Form 3160-5 (June 2019)

Change target formation to First Bone Spring Sands.

Update casing and cement program to current design.

Revised Permit Information 08/01/2023:

521' FNL Revised Wellbore A: KB: 3666' 1207' FEL GL: 3641'

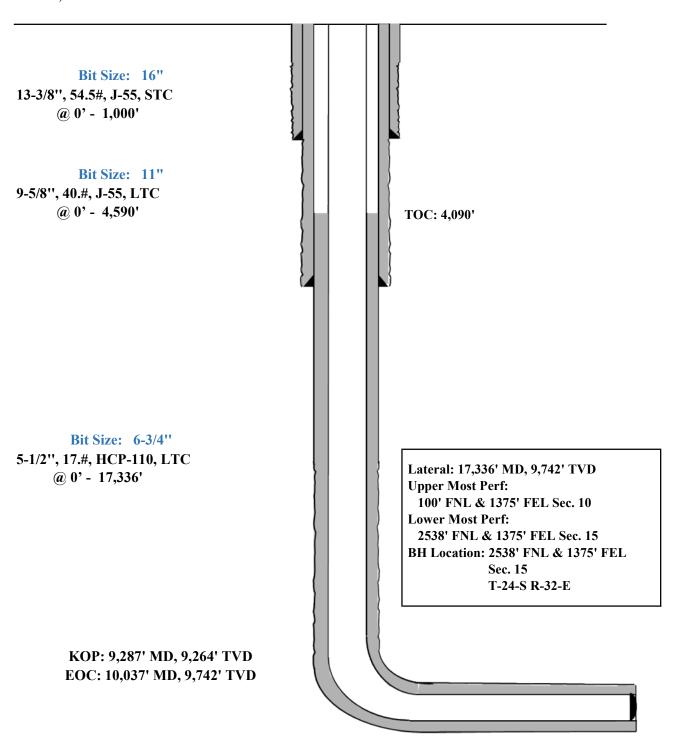
Casing Program A:

Hole	Interval MD		Interval TVD		Csg			
Size	From (ft)	To (ft)	From (ft)	To (ft)	OD	Weight	Grade	Conn
16"	0	1,000	0	1,000	13-3/8"	54.5#	J-55	STC
11"	0	4,614	0	4,590	9-5/8"	40#	J-55	LTC
6-3/4"	0	17,336	0	9,742	5-1/2"	17#	HCP-110	LTC

Variance is requested to waive the centralizer requirements for the 9-5/8" casing in the 11" hole size. An expansion additive will be utilized, in the cement slurry, for the entire length of the 11" hole interval to maximize cement bond and zonal isolation.

Variance is also requested to waive any centralizer requirements for the 5-1/2" casing in the 6-3/4" hole size. An expansion additive will be utilized, in the cement slurry, for the entire length of the 6-3/4" hole interval to maximize cement bond and zonal isolation.

521' Revised Wellbore B: KB: 3666' GL: 3641'

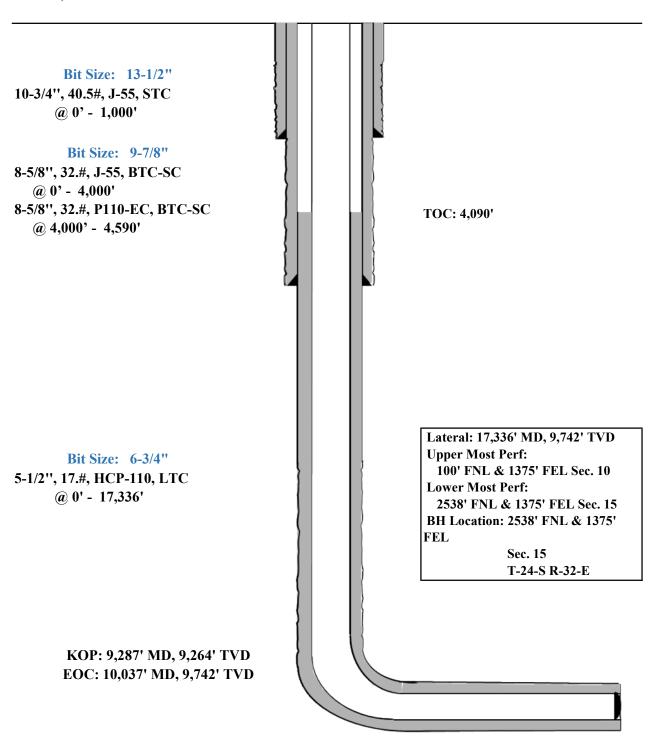
Casing Program B:

Hole	Interval MD		Interval TVD		Csg			
Size	From (ft)	To (ft)	From (ft)	To (ft)	OD	Weight	Grade	Conn
13-1/2"	0	1,000	0	1,000	10-3/4"	40.5#	J-55	STC
9-7/8"	0	4,023	0	4,000	8-5/8"	32#	J-55	BTC-SC
9-7/8"	4,023	4,613	4,000	4,590	8-5/8"	32#	P110-EC	BTC-SC
6-3/4"	0	17,336	0	9,742	5-1/2"	17#	HCP-110	LTC

Variance is requested to waive the centralizer requirements for the 8-5/8" casing in the 9-7/8" hole size. An expansion additive will be utilized, in the cement slurry, for the entire length of the 9-7/8" hole interval to maximize cement bond and zonal isolation.

Variance is also requested to waive any centralizer requirements for the 5-1/2" casing in the 6-3/4" hole size. An expansion additive will be utilized, in the cement slurry, for the entire length of the 6-3/4" hole interval to maximize cement bond and zonal isolation.
